PARTS & SERVICE NEWS

REF NO.	AA02204
DATE	Sept. 5, 2002

- SUBJECT:** INTRODUCTION OF IMPROVED NEEDLEBEARING AND PLANETARY GEAR SHAFT
- PURPOSE:** To introduce the improved needle bearing and planetary gear shaft with increased reliability for use with the 1st clutch train of the transmission assembly

WA700-1, -3

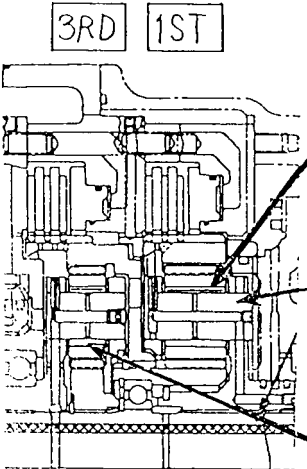
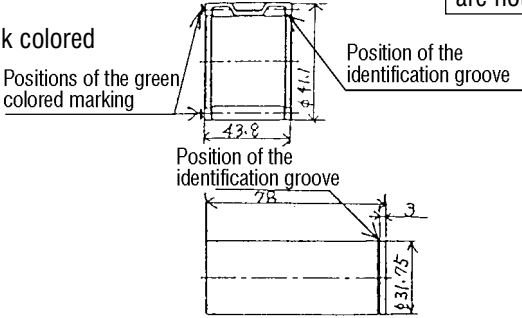
1st train (The parts life can be prolonged only when the needle bearing and the planetary shaft are replaced in a set simultaneously.)

Part No. (Part name)	Q'ty/machine	Identification method
(New part) 428-15-19312 (Bearing)	4 pcs.	Front surface of the retainer Silver colored Side surface of the retainer Green color marking (On one side only) Bore surface of the retainer Identification groove is being made. (1 groove)
(Current part) 428-15-19311 (Bearing)	4 pcs.	Front surface of the retainer Black colored
(New part) 428-15-00211 (Shaft ass'y)	4 pcs.	Identification groove is being made. (1 groove)
(Current part) 428-15-00210 (Shaft ass'y)	4 pcs.	Without identification groove

WA600-1, -3, WF600T-1

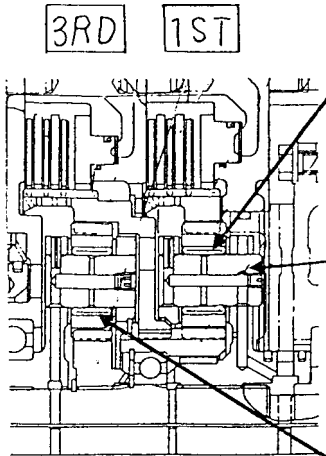
1st train (The parts life can be prolonged only when the needle bearing and the planetary gear shaft are replaced in a set simultaneously.)

Part No. (Part name)	Q'ty/machine	Identification method
(New part) 426-15-12962 (Bearing)	4 pcs.	Front surface of the retainer Silver colored Side surface of the retainer Green color marking (On one side only)
(Current part) 426-15-12961 (Bearing)	4 pcs.	Front surface of the retainer Black colored
(New part) 426-15-00161 (Shaft ass'y)	4 pcs.	Identification groove is being made. (1 groove)
(Current part) 426-15-00160 (Shaft ass'y)	4 pcs.	Without identification groove

WD600-1

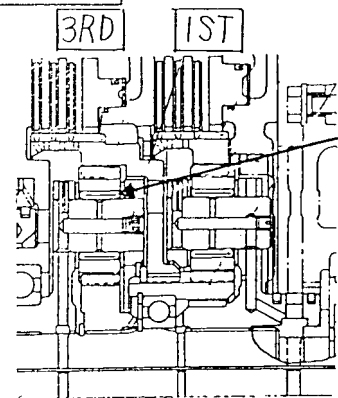
3rd train (These parts should be changed for the parts unification purpose with the 1st train parts on the WA600-1 and WA600-3.)

Part No. (Part name)	Q'ty/machine	Identification method
(New part) 426-15-12962 (Bearing)	4 pcs.	Front surface of the retainer Silver colored Side surface of the retainer Green color marking (On one side only)
(Current part) 426-15-12961 (Bearing)	4 pcs.	Front surface of the retainer Black colored
